PCN-20210121 TE0726-03 DDR3 Change and Product Update

Company	Trenz Electronic GmbH
PCN Number	PCN-20210121
Title	TE0726-03 DDR3 Change and Product Update
Subject	BOM change
Issue Date	2021-01-25

This change affects Trenz Electronic boards TE0726 of Revision 03: TE0726-03-*

old	new
IM4G16D3FABG-125I	IS43TR16256BL-125KBLI

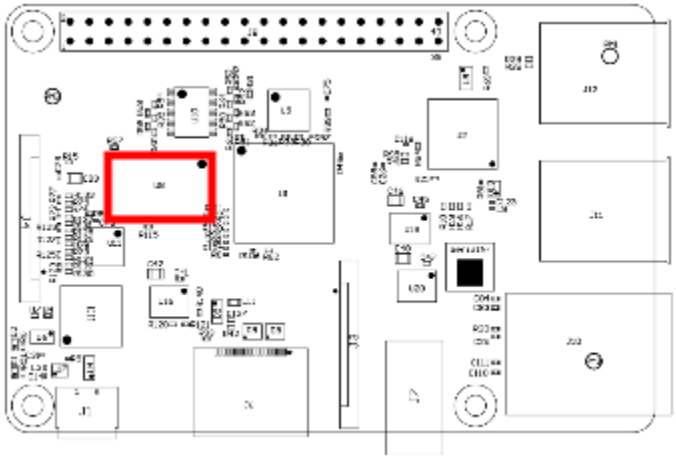
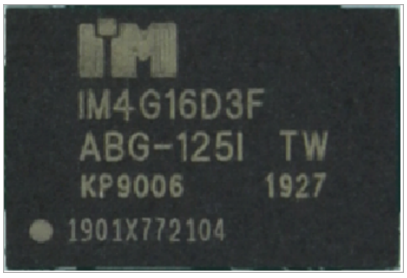
#1 Change DDR3 RAM (U8) from IM4G16D3FABG-125I to IS43TR16256BL-125KBLI

Type: BOM change
Reason: Component is end of life.
Impact: New DDR timings may be considered in designs.

Locate DDR3 RAM (U8) on top side of PCB:
